1958 Agreement:

Proposal for Supplement 1 to the 09 series of amendments to UN Regulation No. 48 (Installation of Lighting and Light- Signalling Devices)

Submitted by the Working Party on Lighting and Light-Signalling*

“Annex 16

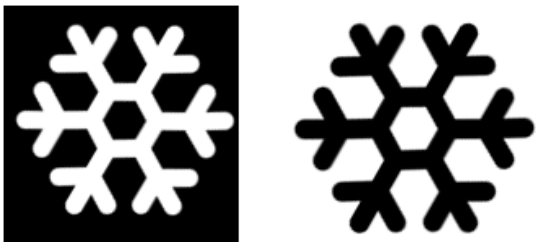
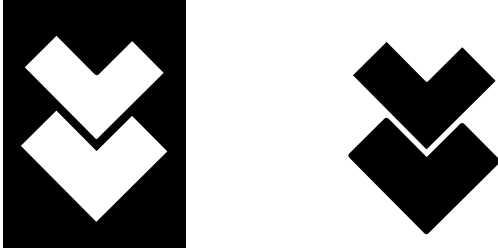
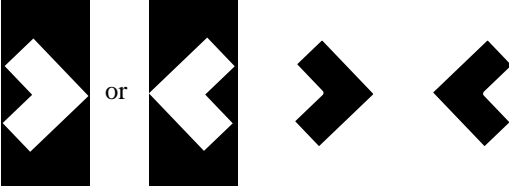
Annex 16, amend to read:

Symbols and patterns for the use as Driver Assistance Projections and Explanations of the Warnings/Highlights

<i>Symbols and Pattern</i>	<i>Use case</i>	<i>Conditions and remarks</i>
	Slippery road warning	
	Risk of collision warning	<p>Triggered when the relative speed is larger than 30 km/h and Risk of Collision Time is less than 1.4 s.</p> <p>Flashing at 4.0 hz +/- 1.0 hz allowed.</p>

Wrong way warning	Activated when the vehicle is entering a one-way road or a highway in opposite direction. Flashing at 4.0 hz +/- 1.0 hz allowed.
	Lane keeping assist warning	Activated if the vehicle unintentionally exits its lane.
 <p>This figure is showing an example of the basic quadrilateral shape of the Driver Assistance Projection for predicted trajectory, as seen from the driver's perspective of a car in straight forward motion. The dashed lines are not part of the projection. They are a representation of the lines delineating the lane on which the vehicle is travelling, and only added to clarify the image and lateral boundaries of the predicted trajectory projection.</p>	Predicted trajectory	This shape may change when adapted in conformity with the requirements in paragraph 5.35.12.
